Addendum 2

Project: **BRFP NUMBER 2324-03 – TROY SCHOOL DISTRICT 2024 SITE IMPROVEMENTS PAVING PROJECTS**

PROJECT: 2024 Troy School District Site Improvements – Paving Projects
DATE: November 14, 2023
FROM: PEA Group
PEA JOB No.: 23-0262
PURPOSE: Addendum Number 2

**TROY
CONTINUING
EDUCATION**

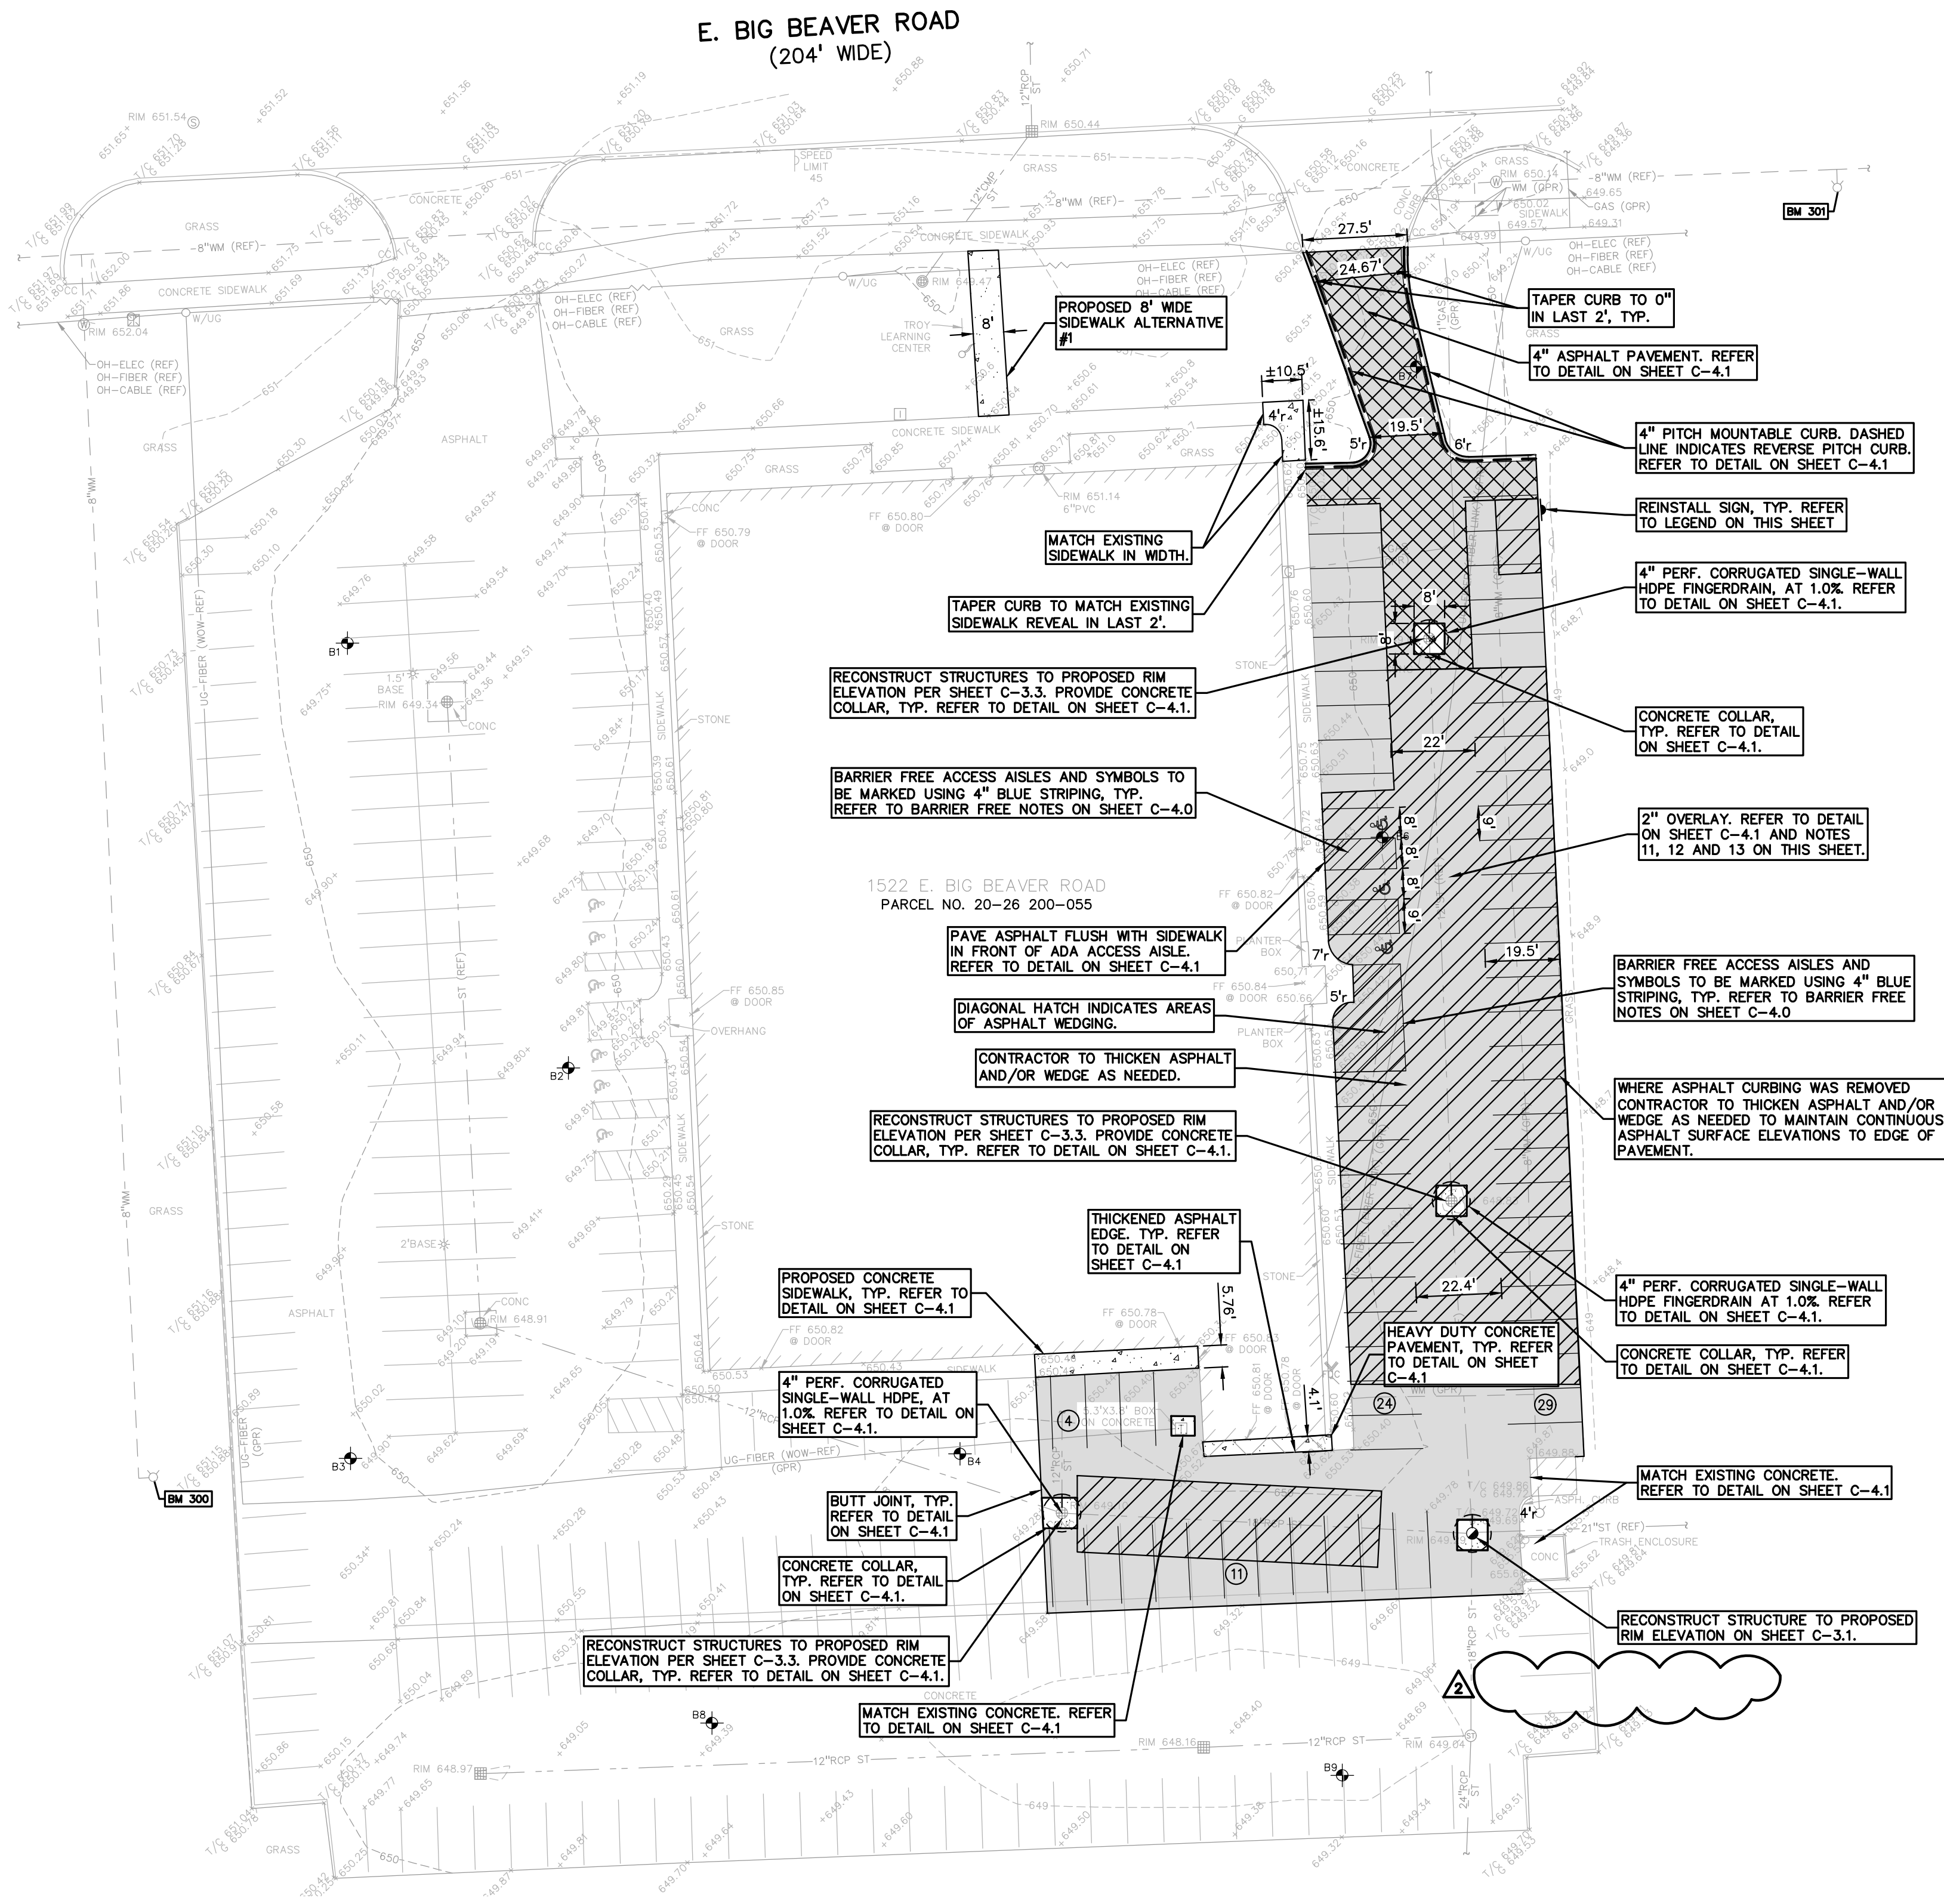
1. The call out for the butt joint along the southern edge of the project was removed.
2. A “Paving Legend” was added to the sheet to indicate area of 2” Overlay, 4” Asphalt Pavement and 2” Overlay with wedging to match the hatching on the sheet.

C-3.1

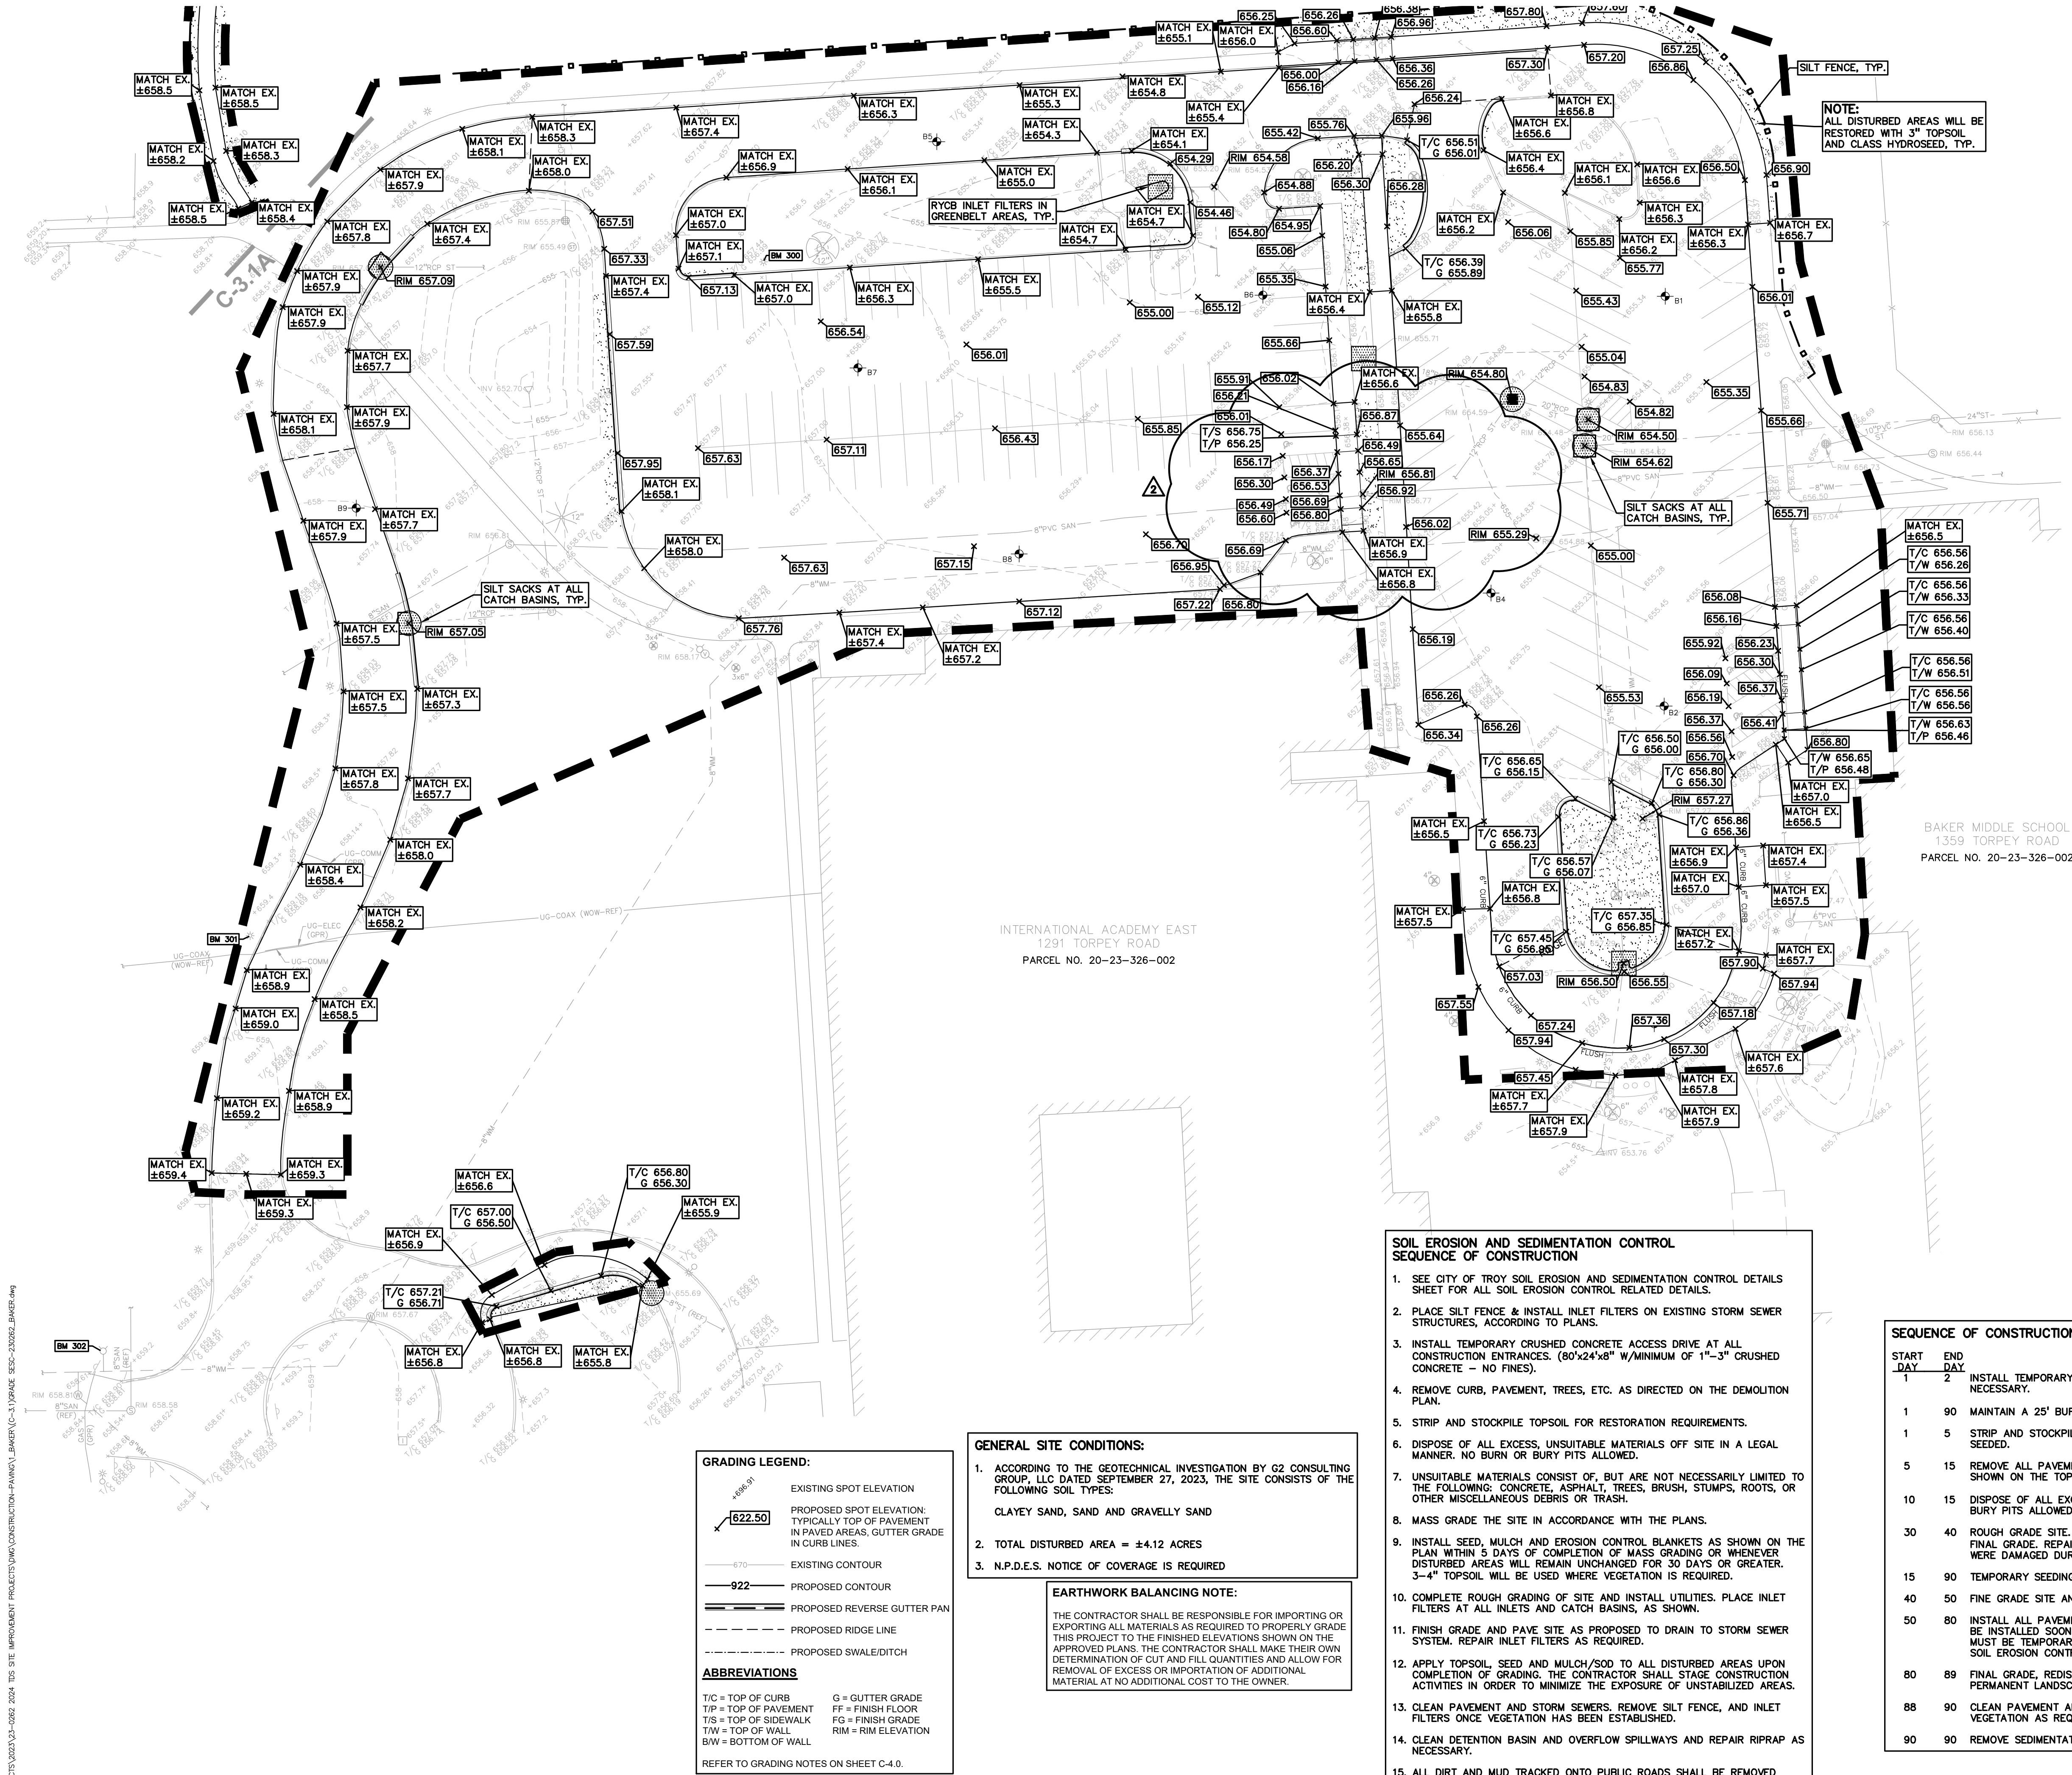
1. The grading for the ADA ramp on the east side of the western parking lot was updated.
